Interim Reclamation and Stormwater Inspection

Operator: PDC ENERGY INC - #69175

Location ID: 319511

Inspection Photos
Location Name: Zeiler /SW-7 Pad
Location ID: 319511

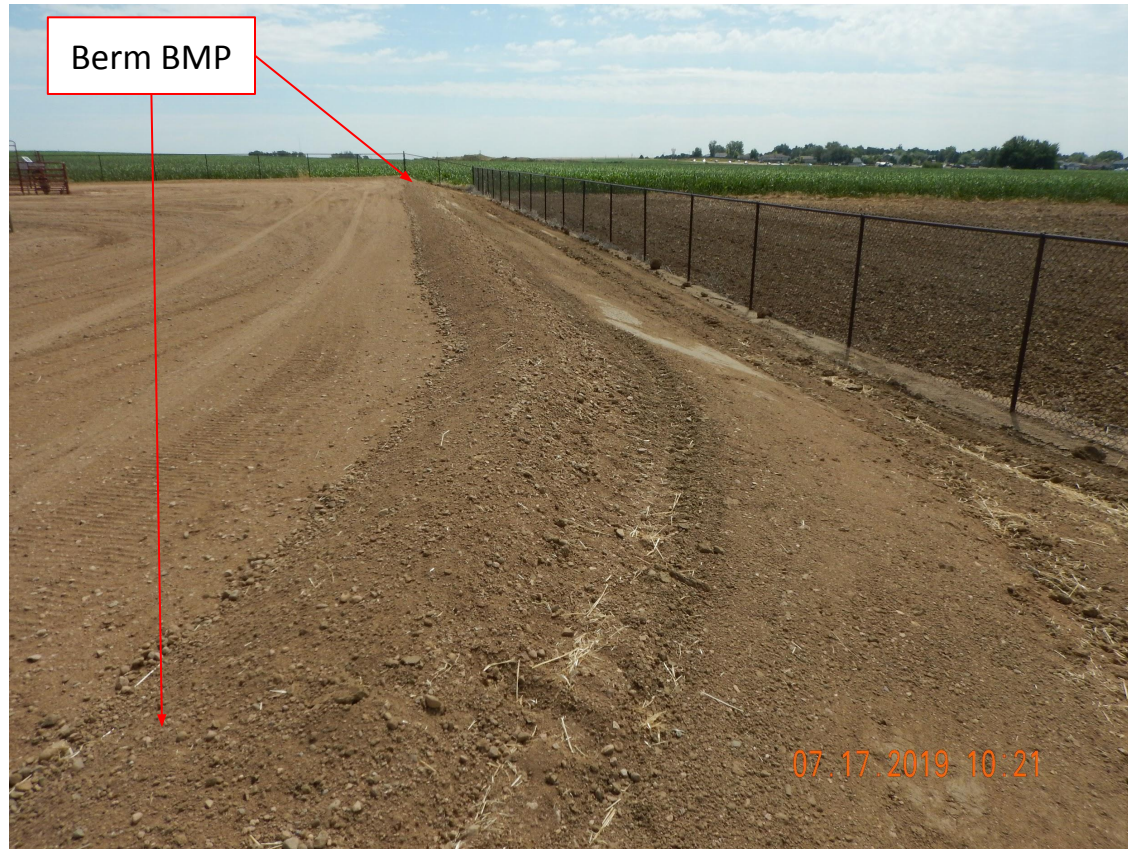
Photo 1. Photo taken from the southwestern location, facing East. Photo illustrates a berm BMP that has been installed along the southern and southwestern perimeter of the well pad. Berm BMP appears to be intended to help direct stormwater to an inlet area along the western well pad perimeter- see Photo 2. Berm BMP has not been compacted or otherwise stabilized.
